UNITED STATES PATENT AND TRADEMARK OFFICE

APPLICATION NO.	FILING DATE	FIRST NAMED INVENTOR	ATTORNEY DOCKET NO.	CONFIRMATION NO.
10/550,247	08/15/2006	Philippe Chavignac	SAIME 3.3-004	1734

Office Action Summary	Application No. 10/550,247	Applicant(s) CHALVIGNAC, PHILIPPE	
	Examiner KRISTEN C. MATTER	Art Unit 3771

DETAILED ACTION

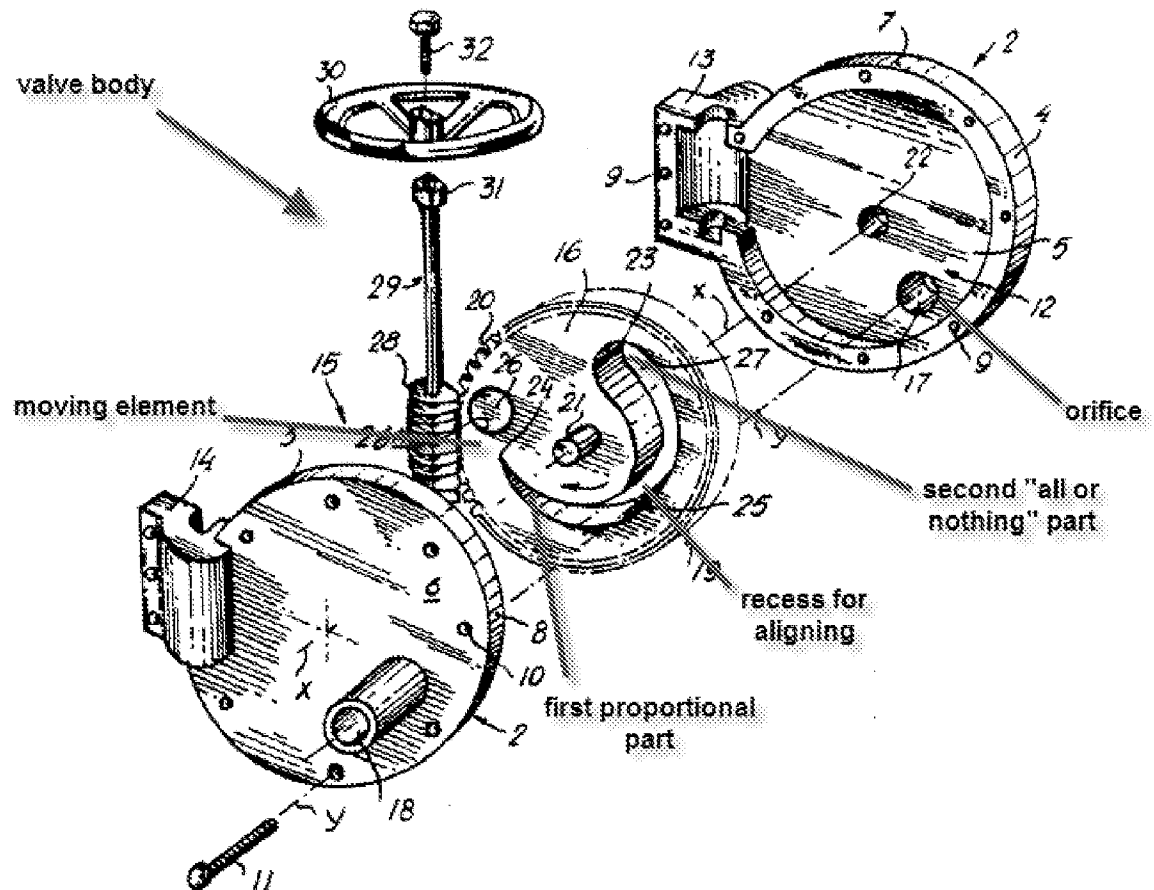
The first part of the recess shown below is triangular at the tip. The second part of the recess is not rectangular. However, it would have been obvious to one of ordinary skill in the art at the time the invention was made to modify the shape to be rectangular because a mere change in shape is generally considered to be obvious to one of ordinary skill in the art. *In re Dailey*, 357 F.2d 669, 149 USPQ 47 (CCPA 1966)

Regarding Claim 8, Torres's valve has the recess shaped so that when the moving element moves from the closed position to the open position, the first part is aligned with the orifice, and the second part is aligned with the orifice if the movement continues (clockwise motion in the figure above).

Regarding claim 9, the base of the triangle of the first part shown above would be parallel to one of the sides of the rectangular end of the recess shown above.
